ENGINEERING REVIEW COMMENTS IN BLUE BOXES WITH BLUE TEXT

Additional comments will be provided upon approval of deviations, clarification and revisions to the drainage report Flying Horse North Filing No. 3

Final Drainage Report

SF2326

MHFD-Detention_PondA.xksm, Basin 11/17/2023, 11:22 AM

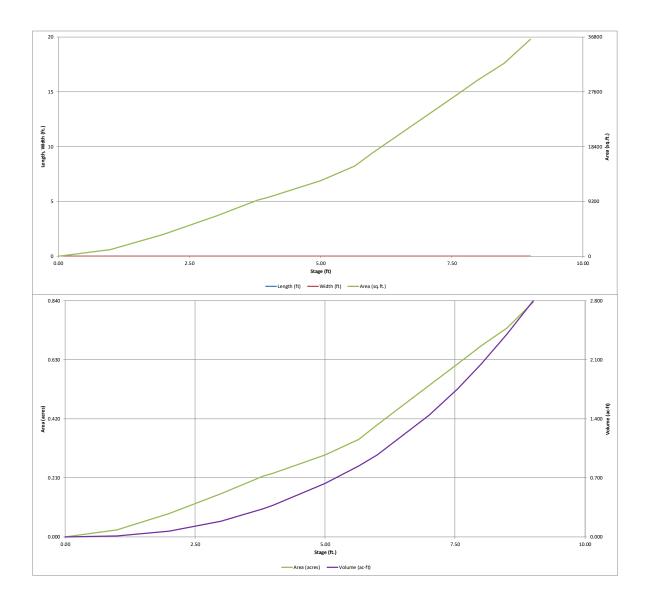
Centroid of Lowest Orifice = 0.00 ft (relative to basin bottom at Stage = 0 ft) Depth at top of Zone using Orifice Plate 5.50 ft (relative to basin bottom at Stage = 0 ft) Orifice Plate: Orifice Vertical Spacing N/A inches Orifice Plate: Orifice Area per Row = N/A sa, inches 5.9' per plans. Verify
